## Memorandum

**To:** Bassett Creek Watershed Management Commission  
**From:** Barr Engineering Co. (Kallie Doeden, Parker Brown, and Karen Chandler, PE)  
**Subject:** Item 5B: Additional Information for Ponderosa Woods Stream Restoration Project Feasibility Study  
BCWMC June 15, 2023 Meeting Agenda  
**Date:** June 8, 2023

FIGURE 1

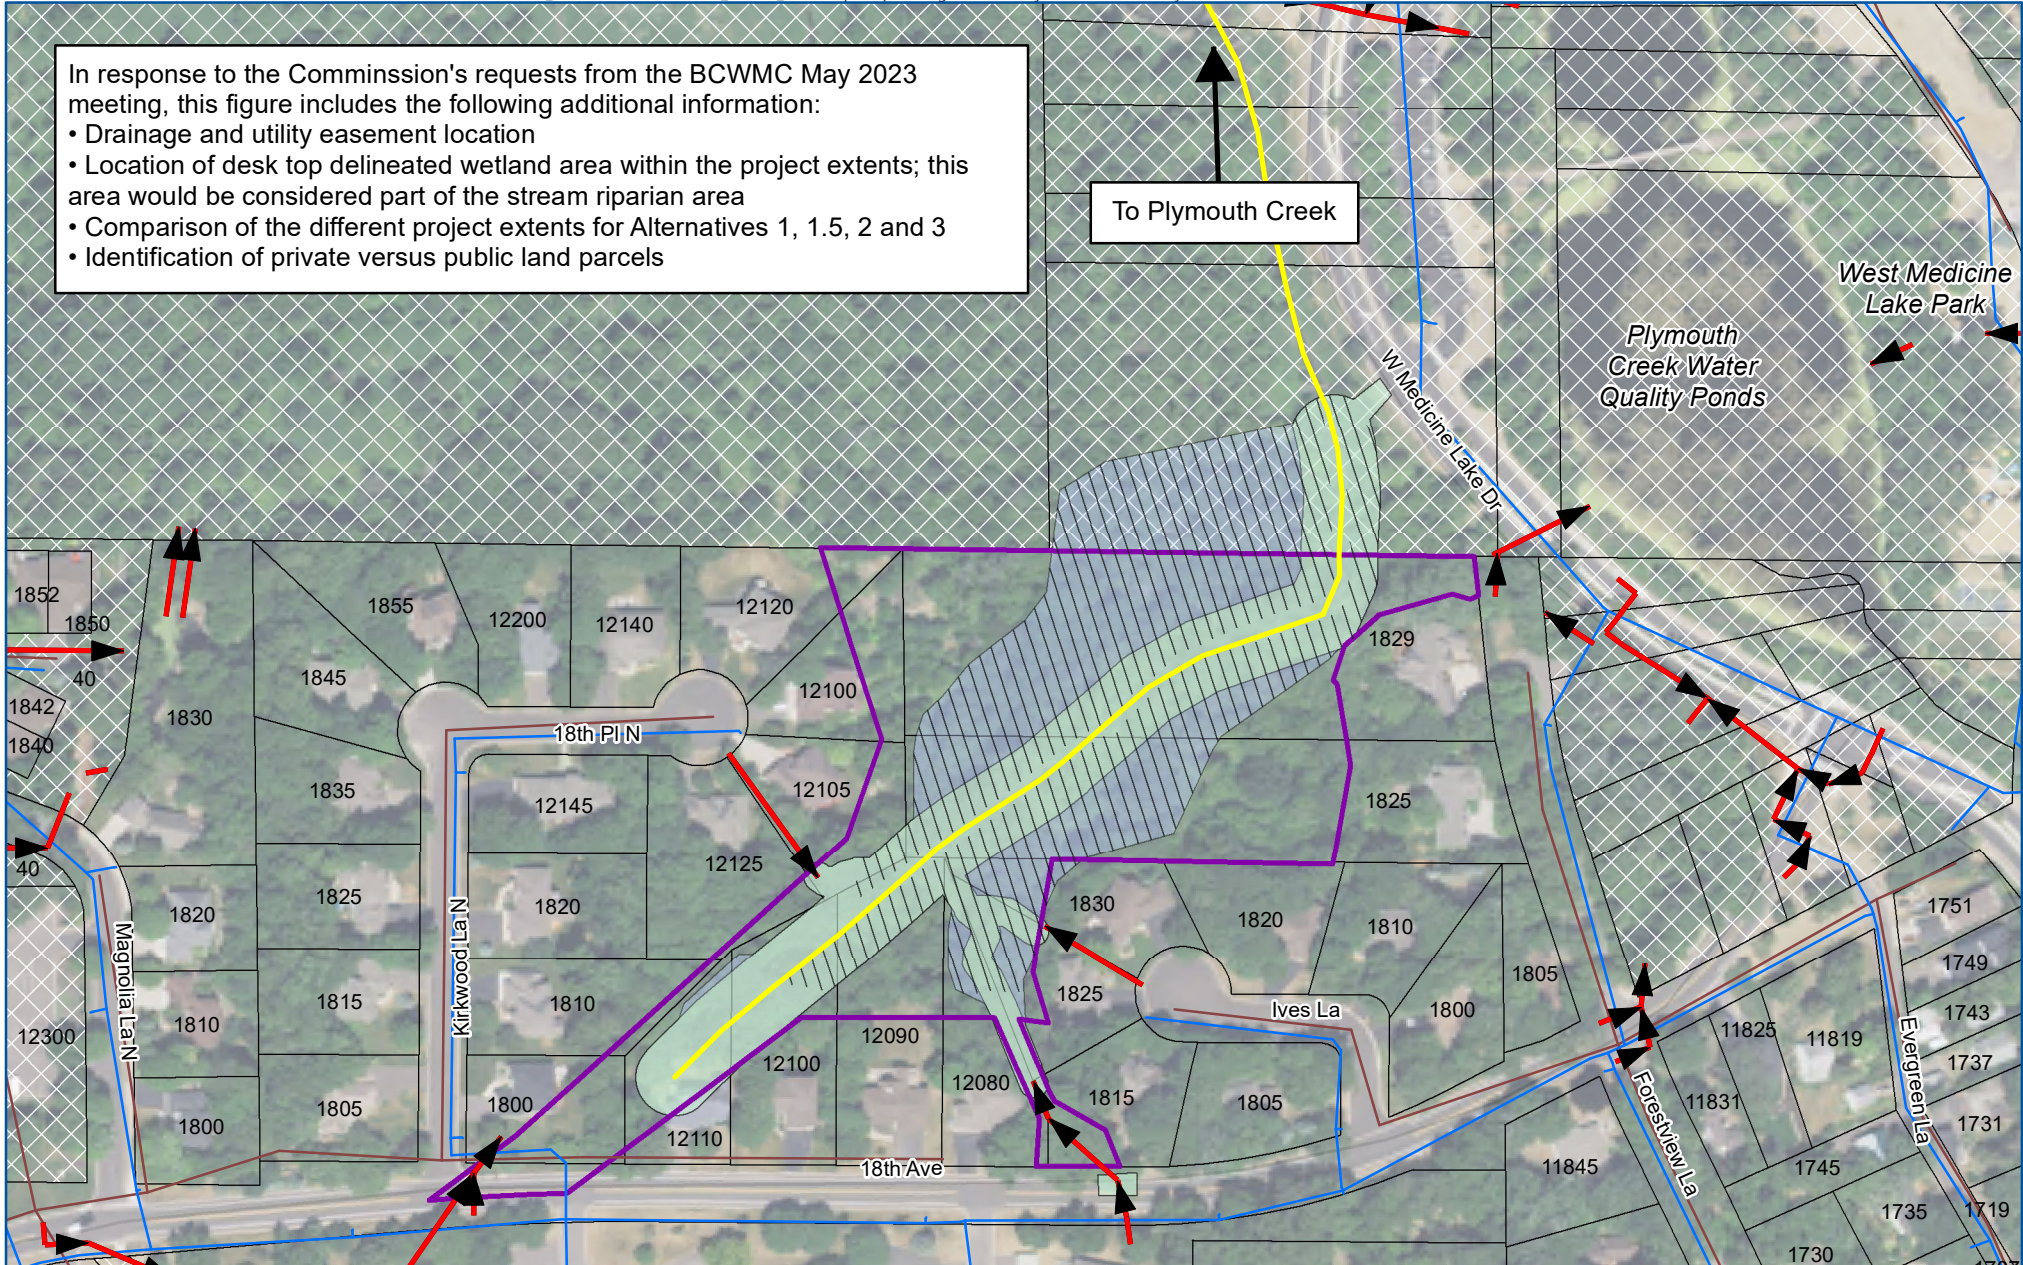
- Drainage and utility easement location
- Location of desktop delineated wetland area within the project extents; this area would be considered part of the stream riparian area
- Comparison of the different project extents for Alternatives 1, 1.5, 2 and 3
- Identification of private versus public land parcels

Figure 1 (attached) shows the additional information.

As presented at the May 2023 Commission meeting, the City has a permanent drainage and utility easement encompassing the entire project area as shown on Figure 1. Therefore, no additional point-of-entry agreements, vegetation management easements, or permanent easements are anticipated for any of the alternatives.

In response to the Commission's requests from the BCWMC May 2023 meeting, this figure includes the following additional information:

- Drainage and utility easement location
- Location of desk top delineated wetland area within the project extents; this area would be considered part of the stream riparian area
- Comparison of the different project extents for Alternatives 1, 1.5, 2 and 3
- Identification of private versus public land parcels

Note: The Commission Engineer performed a desktop evaluation for where the Floodplain Forest Wetland may exist within the project area. A field wetland delineation will be necessary to determine actual extents.
